NEDO-33914-A, Revision 2,  
BWRX-300 Advanced Civil Construction and Design Approach

# **BWRX-300 Advanced Civil Construction and Design Approach**

SUBJECT: FINAL SAFETY EVALUATION FOR GE-HITACHI LICENSING TOPICAL  
REPORT NEDO-33914, REVISION 1, "BWRX-300 ADVANCED CIVIL  
CONSTRUCTION AND DESIGN APPROACH" (DOCKET NO. 99900003)

Figure 1-4: BWRX-300 Reactor Building Shaft Construction

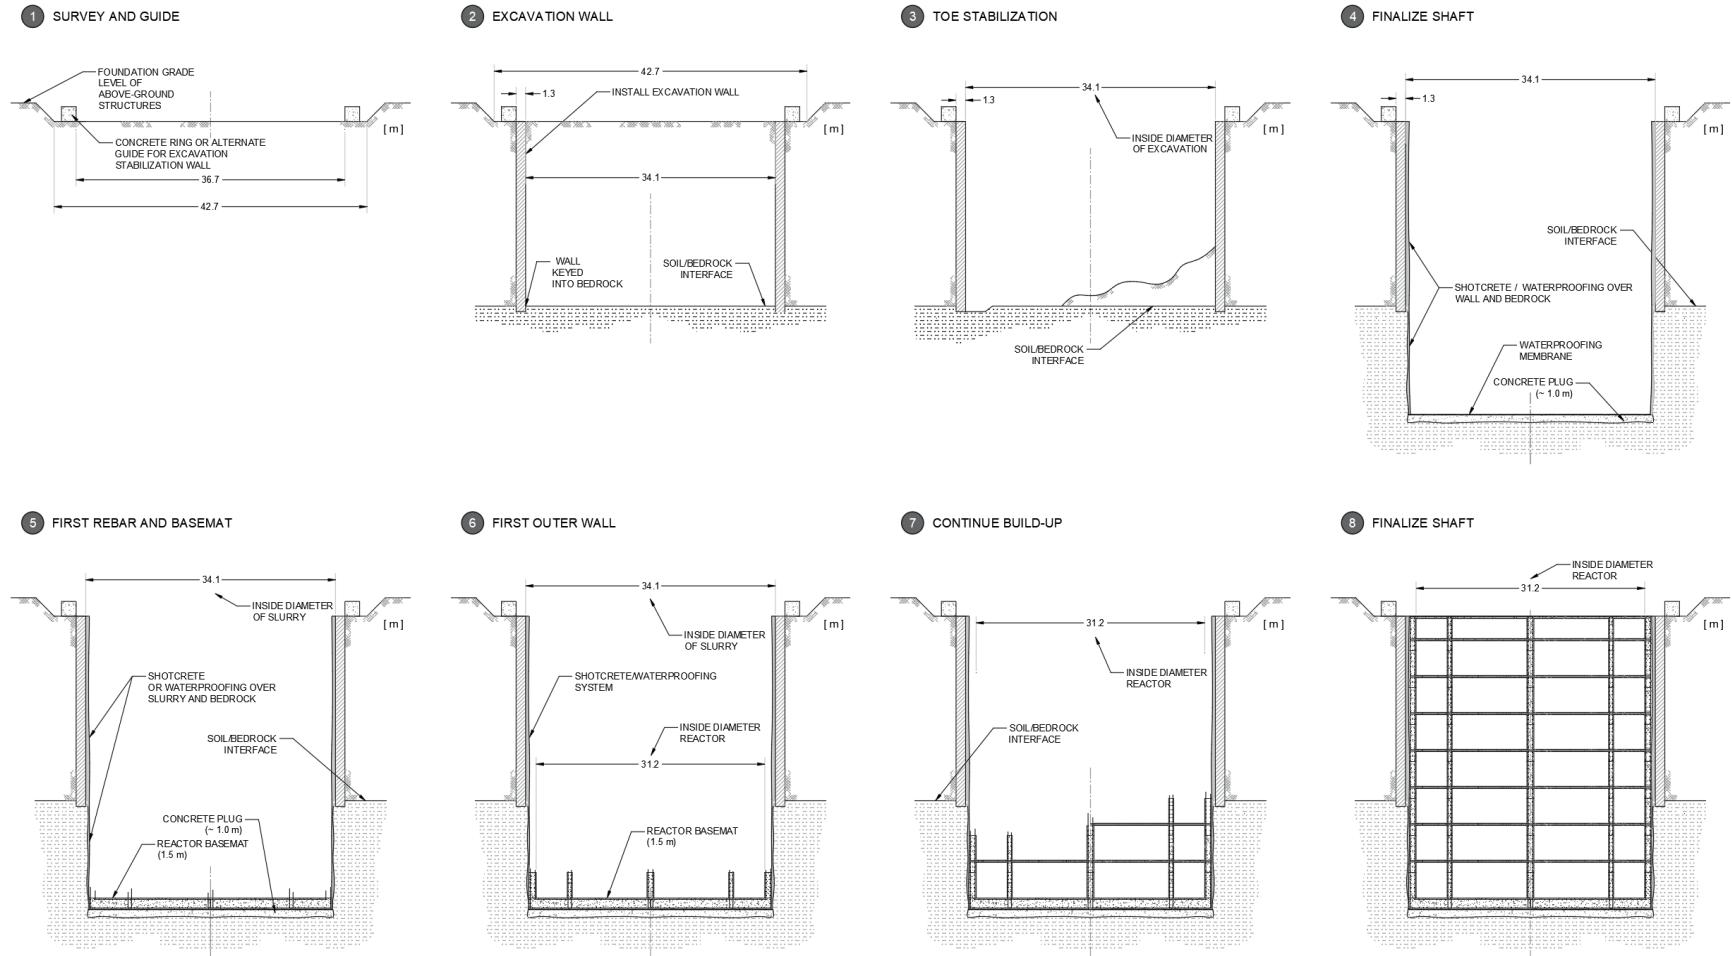
As shown in Figure 1-4 of NEDO-33914, the rock and soil media surrounding the Reactor Building (RB) shaft may not be accessible as the excavation progresses. Excavation support (e.g., slurry shoring wall or similar) will likely be needed for the RB shaft excavation that would make the soil inaccessible from the excavation. Depending on the subsurface conditions at a site, the rock excavation may be accessible for mapping beneath the soil excavation support. As described in Section 3.2.1 of NEDO-33914, mapping the walls and floors of the rock excavation during and at the completion of the rock excavation are intended to be the primary mechanism of confirming the assumptions made about rock media surrounding the RB shaft. Specifically, the orientation, joint characteristics, aperture, spacing, and persistence of the fractures used to characterize the rock mass could be confirmed. However, rock reinforcement, shotcrete, or waterproofing may limit access for mapping the rock excavation at some sites.

Figure 3-1: Preliminary Layout of the BWRX-300 Borings

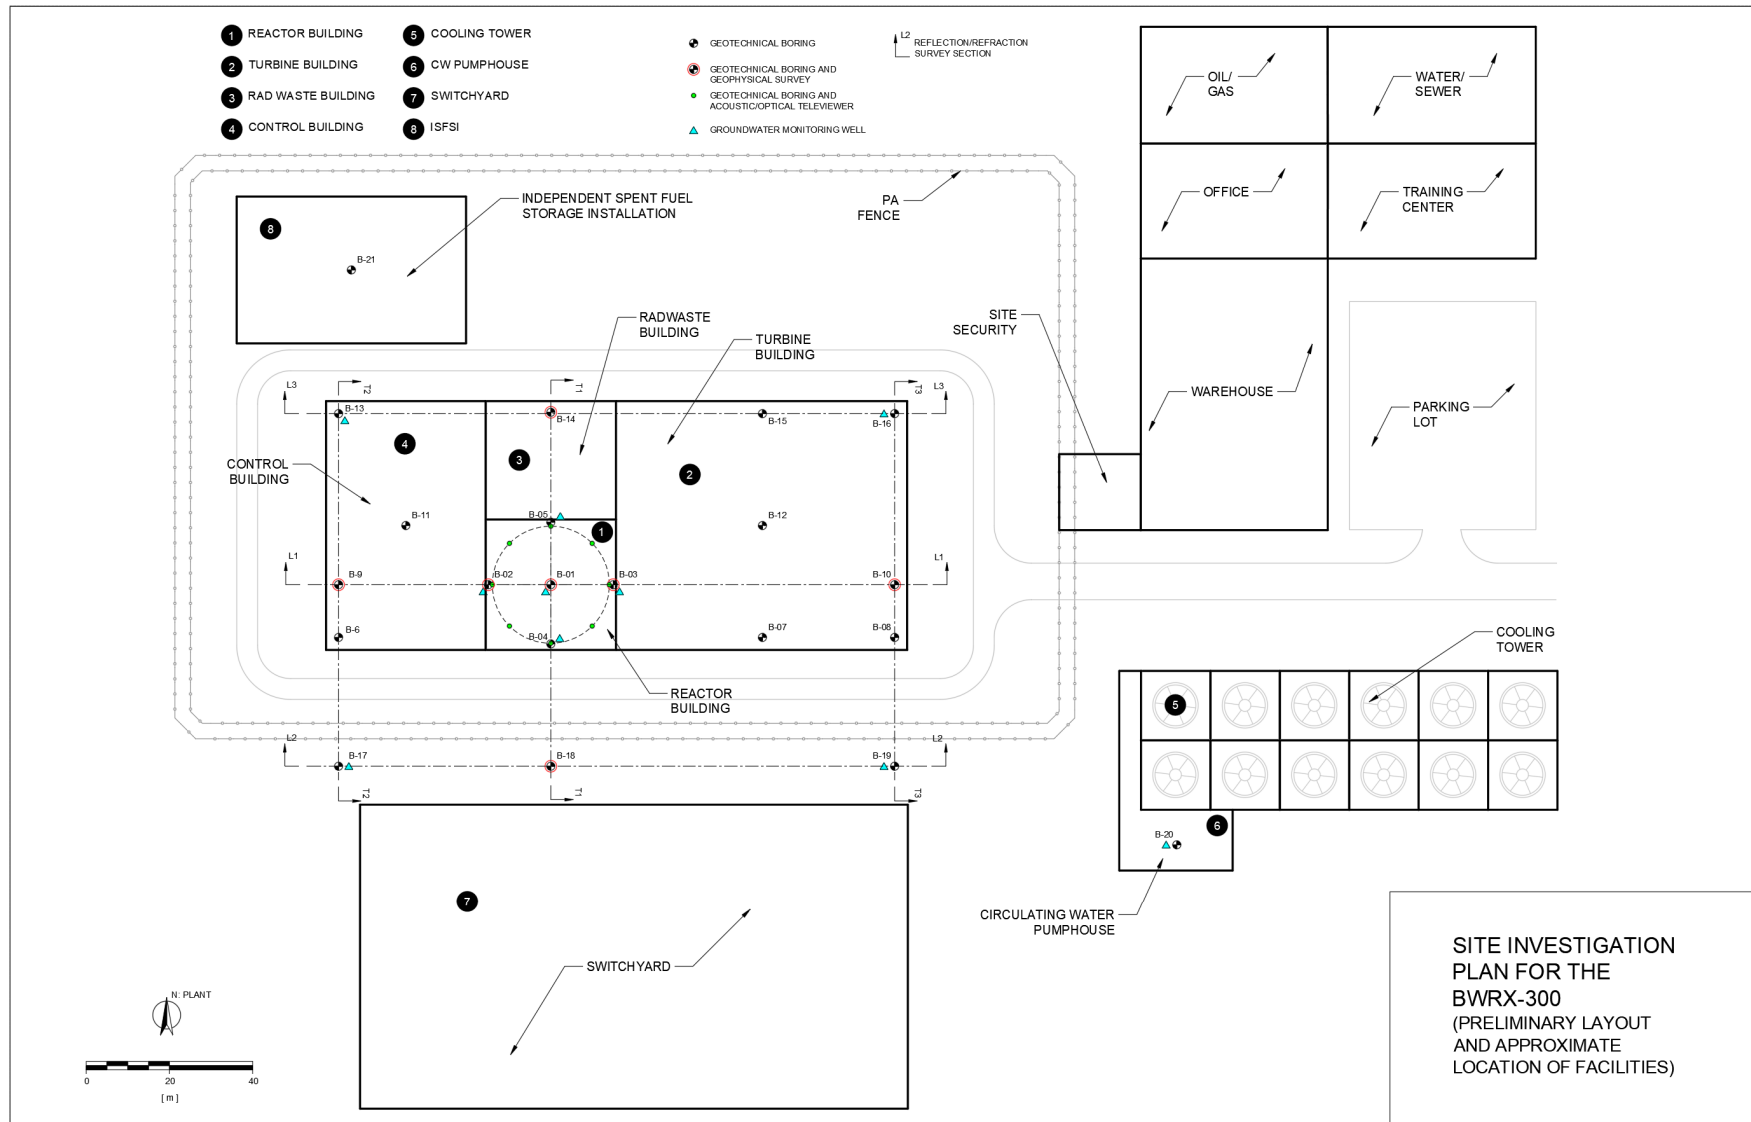
Figure 3-1 of the LTR shows a preliminary layout of the BWRX-300 SMR single unit plant and preliminary borehole locations for geotechnical and geophysical investigations for a typical site. Expected type and number of tests are given in Table 3-1. The LTR states in Section 3.1.1, that a minimum of 21 borings are anticipated for a BWRX-300 SMR installation, more than the recommended number of borings in Appendix D of RG 1.132 to ensure adequate characterization of the subsurface properties surrounding the RB structure. GEH has set the maximum required depth of these boreholes at approximately 120 m based on the change in in situ vertical stress.

The eight geotechnical boring/borehole televiewer locations are intended to collect a substantial amount of data on the perimeter of the potential RB shaft excavation (Figure 3-1 of NEDO-33914). This information would include the recovered soil samples and rock cores at the geotechnical boring in the center of the RB shaft and the recovered soil samples, recovered rock cores and borehole viewers at eight perimeter RB shaft locations to collect additional data on soil and rock properties. Geophysical surveys would also be completed in three of the geotechnical boring locations. The additional data are intended to provide substantial information on the soil and rock properties prior to excavating and sufficient information to compensate for limited inspections of the soil and rock mass when access is limited by the excavation methods.

**Figure 3-2: Framework of Structures Monitoring and Aging Management Program**

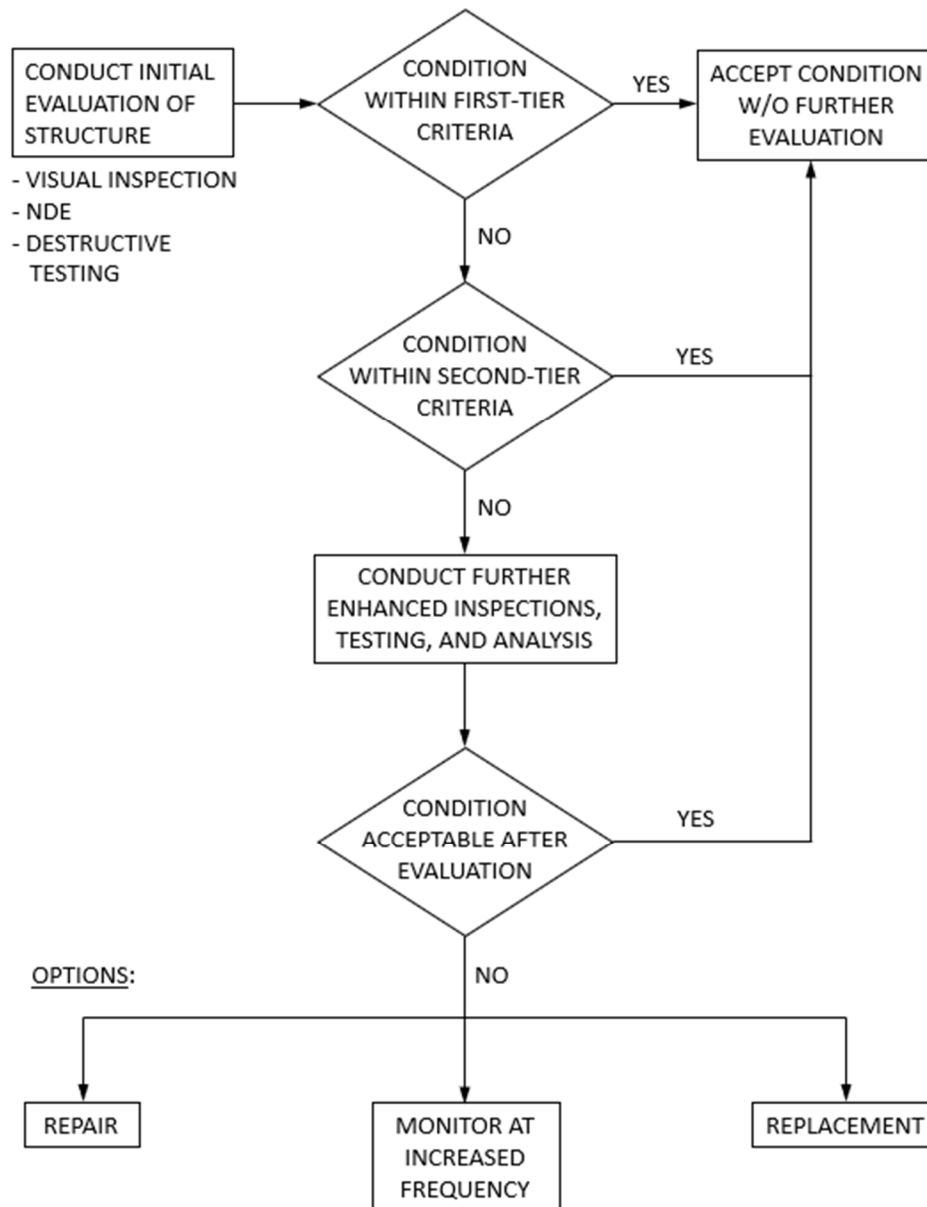
The LTR states that structural evaluation would follow the logic tree as shown in LTR Figure 3-2. The SMAMP has three tiers. In Tier 1, structures would be evaluated against qualitative and quantitative thresholds for visual inspections or condition surveys (First tier criteria) following Section 5.1 of ACI 349.3R. If a structure fails in Tier 1 evaluation, it would be subjected to Tier 2 evaluation. In Tier 2, structures would be evaluated against qualitative and quantitative thresholds for observed degradation in accordance with Section 5.2 of ACI 349.3R. Observed conditions failing the Tier 2 criteria would be evaluated to a Tier 3 evaluation. In Tier 3, structures would be evaluated using more enhanced methods to assess the structural condition. This evaluation would follow Section 5.3 of ACI 349.3R. Any corrective actions needed for a structure would follow the guidance given in Chapter 8, Repair, of ACI 349.3R. Provisions of the SMAMP would also include periodic sampling and testing of groundwater to assess whether the below-grade structures are exposed to an aggressive environment. If necessary, addition site-specific criteria would be developed.

The staff finds from the description of the SMAMP in the LTR that it would be designed following the national standard ACI 349.3R, and therefore the design of the program is reasonable. The definitions of the three tiers of evaluation follows ACI 349.3R. The logic tree for evaluation, as shown in Figure 3-2 of the LTR, is from Figure 5.1 of ACI 349.3R. The personnel conducting the evaluations shall be trained as per Chapter 7 of ACI 349.3R. Any remedial action needed would be in accordance with ACI 349.3R. The staff also finds that this section of the LTR is consistent with the provisions given in the latest version of ACI 349.3R, "Report on Evaluation and Repair of Existing Nuclear Safety-Related Concrete Structures," 2018. Based on the above, the staff finds that the description of the BWRX-300 SMAMP is reasonable as it is based on a recognized standard.

**Figure 3-3: Field Instrumentation and Monitoring**

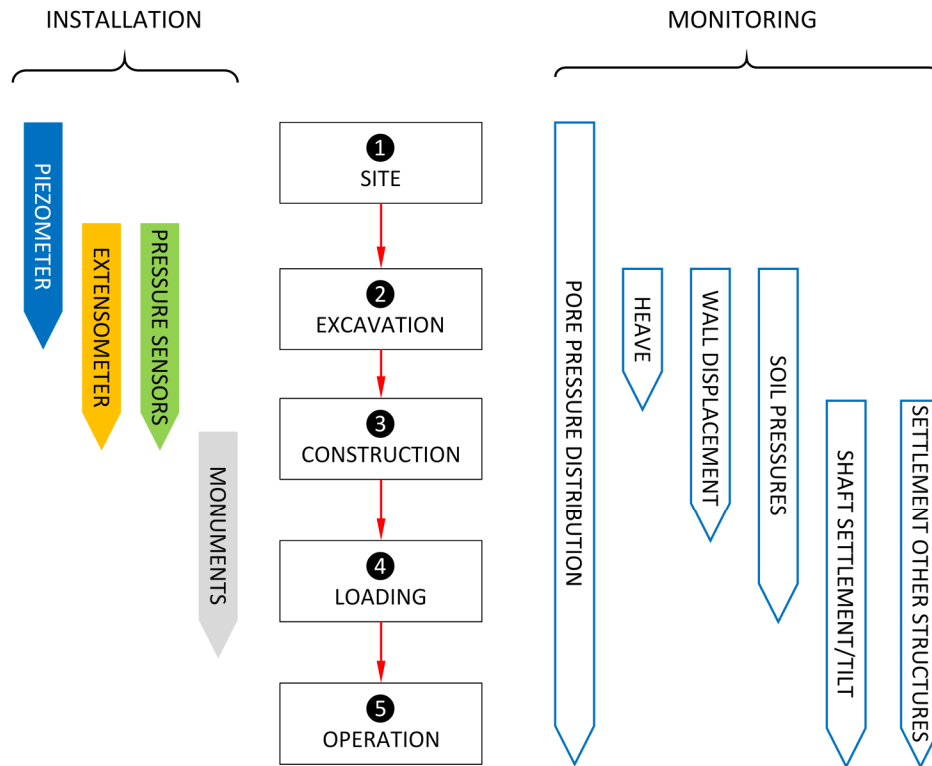
The guidance for developing a suitable instrumentation and monitoring plan is provided in Figure 3-3 of NEDO-33914 with the required implementation periods for different monitoring instruments. Different responses shall be monitored at different stages of the project with a combination of permanent and temporary instrumentation. Water levels and pore pressures in soil and rock are monitored from the site characterization through operation. For the Reactor Building (RB) shaft, heave at the base of the excavation is temporarily monitored during excavation; wall displacements are temporarily monitored during excavation and construction; and, earth pressures are temporarily monitored through excavation, construction, and loading. Settlement of the RB shaft and other structures and tilt of the RB shaft is permanently monitored through construction, loading, and operation of the BWRX-300.

**Figure 4-2: Interface Rheologic Modeling**

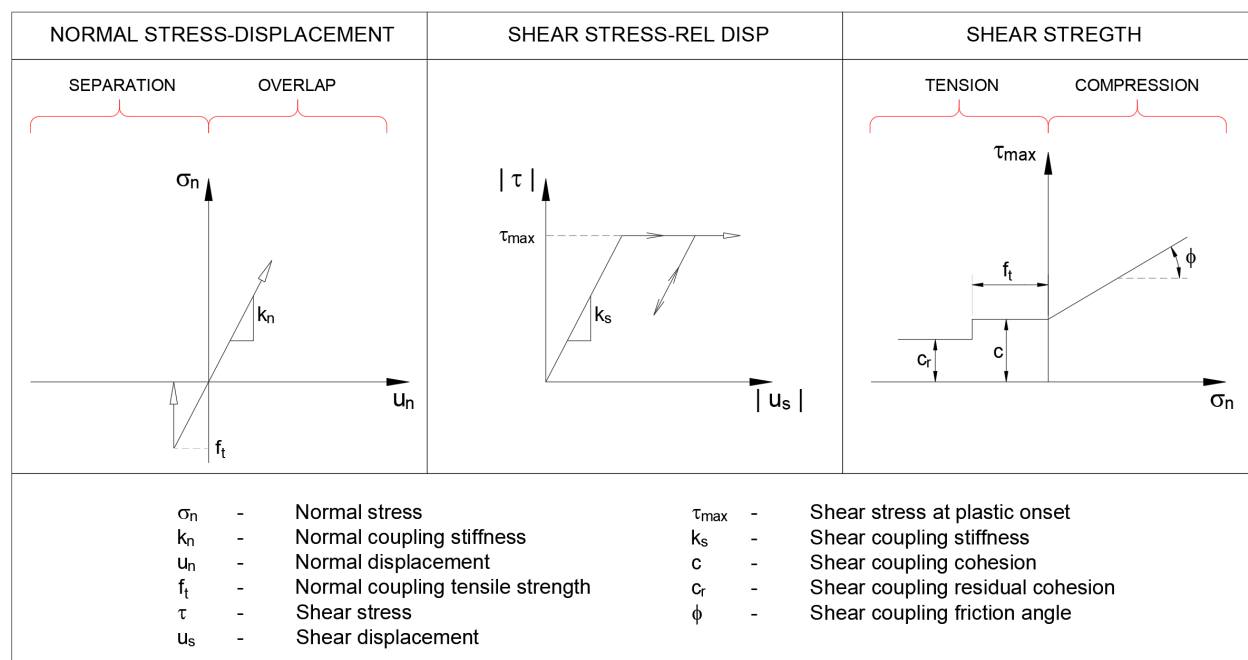
The LTR has provided the interface rheological model typically used with the BWRX-300 SMR in LTR Figure 4-2. Two sets of springs, one along and another across the interface, between two opposing sides of an interface are used as the interface element in the numerical model. The slippages along and opening/closing across the interface are controlled by these two springs. A series of these spring couplers would model the response of the entire interface. The relative sliding (shear) response of each spring along the interface is controlled by its stiffness. The LTR is proposing to use the elastoplastic Mohr-Coulomb criterion to model the shear behavior along the interface. The dilation/contraction or opening/closing of the interface is controlled by the normal stiffness of the spring and will be modeled using a tensile strength cut-off of the spring.

GEH has proposed that the parameters of the interface model, as shown in Figure 4-2 of the LTR, would be determined from the laboratory tests discussed in LTR Section 3.1.2. The LTR has also mentioned use of information collected in LTR Section 3.1.3, Characterization of Rock Mass Properties, to determine the interface parameters of the interface between the structure and the surrounding media. GEH, in response to the NRC Question 02.05.04-01, states that direct shear and/or triaxial test would be performed on rock discontinuity samples to estimate the interface properties.

The staff agrees with GEH that to model the natural discontinuities using the rheological model shown in LTR Figure 4-2 is reasonable because this rheological model has been used in numerous projects around the world and is commonly used in the mining and construction industries. The staff finds the proposal to estimate the model parameters from laboratory testing of samples of natural discontinuities, collected during field investigation at the site, reasonable as the parameters would be measured directly from samples containing actual discontinuities. The staff also agrees that the residual strength parameters of a natural discontinuity after small slippage would be smaller than the peak values. Strength reduction from the peak state to the residual state of the natural discontinuities is appropriate; however, the staff concludes that the minimum peak values of a set of discontinuities represent the peak value of the weakest discontinuity. The staff notes that in future licensing applications, the staff will review the parameters of the rheological model (Figure 4-2) of natural discontinuities from the laboratory tests. This review will address, as discussed above, the following items: (1) reduction of peak shear strength to residual shear strength of a discontinuity and (2) the minimum peak shear strength that is the shear strength of the weakest discontinuity in the discontinuity set.

Figure 4-2 shows the rheological model of an interface to be used in the Foundation Interface Analysis (FIA) with several parameters, such as,  $k_n$ ,  $\sigma_t$ ,  $\tau_{max}$ ,  $k_s$ ,  $C$ ,  $C_r$ ,  $\phi$ . These parameters determine whether the interface slides (shear failure) or dilates (tensile failure) under the imposed loads including the load from the safe shutdown earthquake (SSE). The response of both soil and rock media surrounding the Reactor Building (RB) shaft to the imposed loads significantly affects the loads imposed on the RB walls. In addition, the loads imposed on the RB wall may not be symmetric around the shaft walls, especially in the rock medium.

It is not clear from the discussions given in Site Investigation Program (Section 3.1.1) and Laboratory Testing Program (Section 3.1.2) whether a specific program would be developed to collect the necessary samples at the site and conduct specific tests at the laboratory to determine the parameters of the FIA model, as shown in Figure 4-2, or any other model to be used to represent

The sample collection and testing program for each site will be based on the presumed subsurface conditions. Depending on the selected software used for the FIA model, the sample collection and testing program will be adjusted to characterize the soil and rock parameters. Figure 4-2 in Licensing Topical Report (LTR) NEDO-33914 provides example interface models that could be used for the BWRX-300 FIA model. Interface models will be selected considering the specific site conditions and analysis requirements. NEDO-33914 provides the general design approach and appropriate guidance to develop these plans and programs following Regulatory Guide (RG) 1.132 (Reference 01-1) and RG 1.138 (Reference 01-2).

Figure 4-2 of NEDO-33914 provides an example model to simulate interactions at the RB wall/soil, RB wall/rock, soil/rock, and rock/rock interfaces. The model consists of two sets of elastic-perfectly plastic springs to simulate potential sliding and gapping at the interfaces. The properties for the interface model can be divided into strength properties, such as  $f_t$ ,  $\tau_{max}$ ,  $c$ ,  $c_r$ , and  $\phi$ , and elastic stiffness properties, such as  $k_n$  and  $k_s$ . The strength properties are important because they determine the plastic deformations caused by either shear or tensile failures at the interface.

If the example interface model in Figure 4-2 of NEDO-33914 is not used, the site investigation and laboratory testing programs shall be modified to determine the parameters for the selected interface model.
